OSSF Inspection Sheet

Permit of Authorization to Construct an On-Site Sewage Facility Permit Valid For One Year From Date Issued

Permit Number: 118571
Issued This Date: 05/16/2025
This permit is hereby given to: Silver Cactus LLC

**Re: Silver Cactus LLC
Canyon Lake Village Unit 1 Lot 16 Block 2
Application for Permit for Authorization to Construct an On-Site
Sewage Facility (OSSF)**

PLASTIC LINER DETAILS

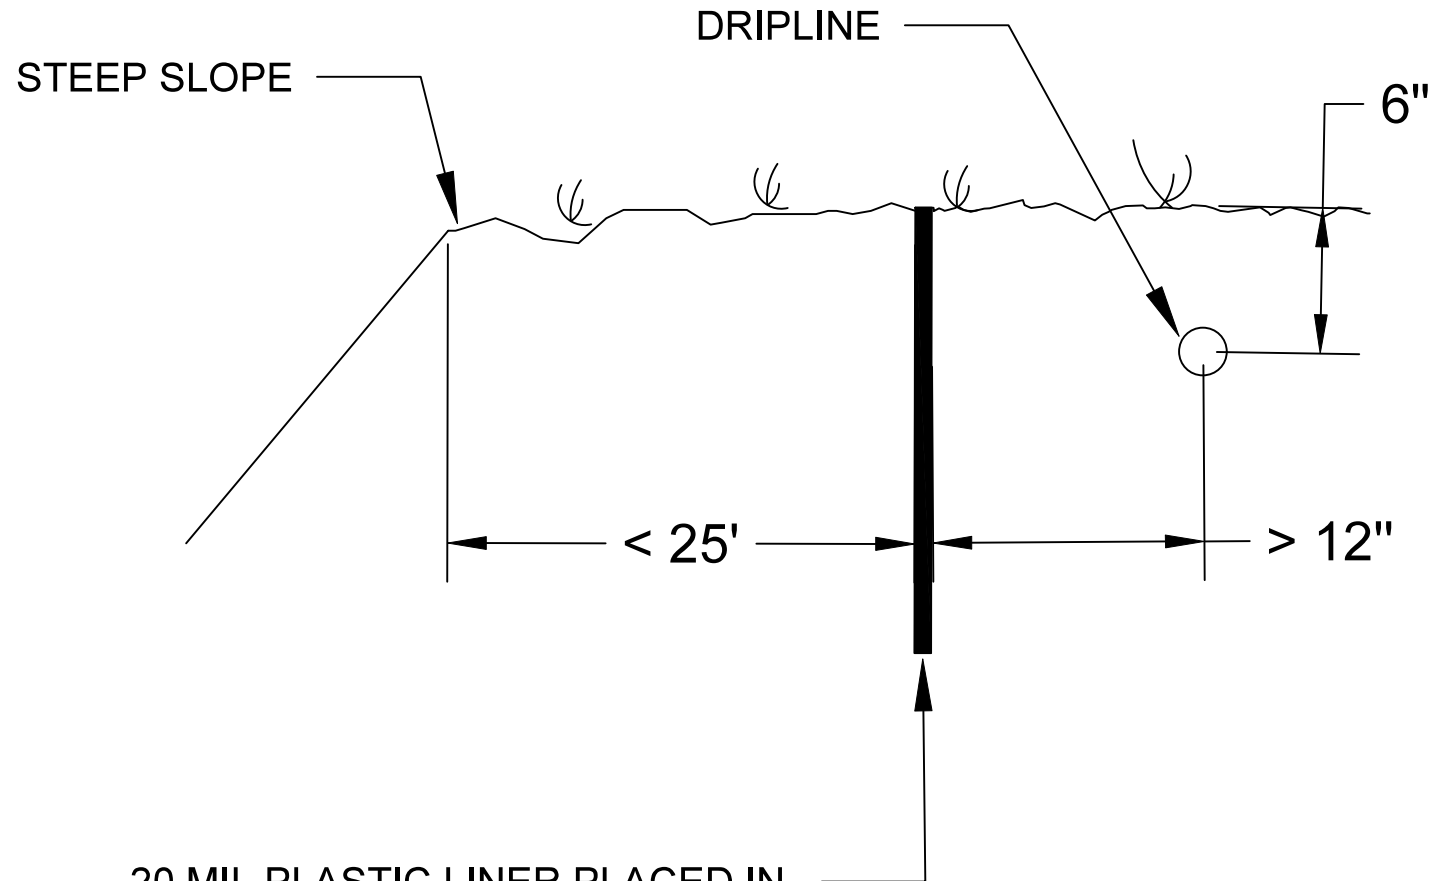
- ✓ There is a steep slope within the required separation distance to the drip field.
- ✓ Is there a purpose for the retaining wall shown on the design?
- 3. Revise as needed and resubmit.

20 MIL PLASTIC LINER PLACED IN
A TRENCH THAT IS A MINIMUM
DEPTH OF 18" TO PREVENT
SEEPAGE WHERE THE DRIPLINES
ARE WITHIN 25' OF STEEP SLOPE.
